Product Change Notice (PCN)

PCN Number: PCN-65630262R-01

Product(s) Affected: PDS1-M Series

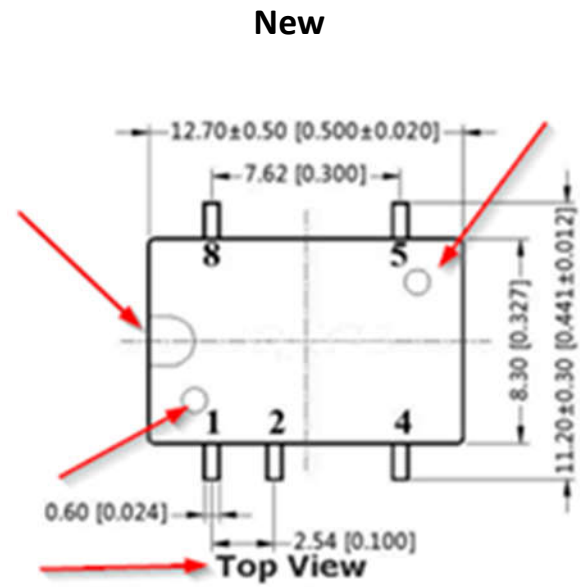
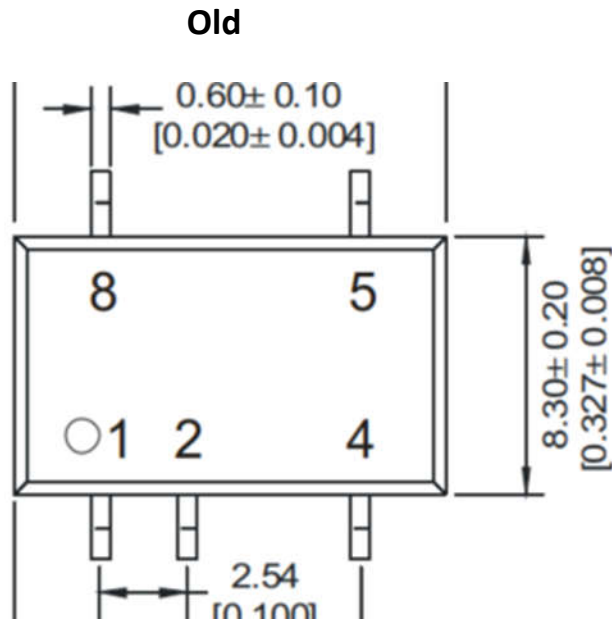
Description of Change: Mold update causing minor housing changes from manufacturing contact points. See pictures below.
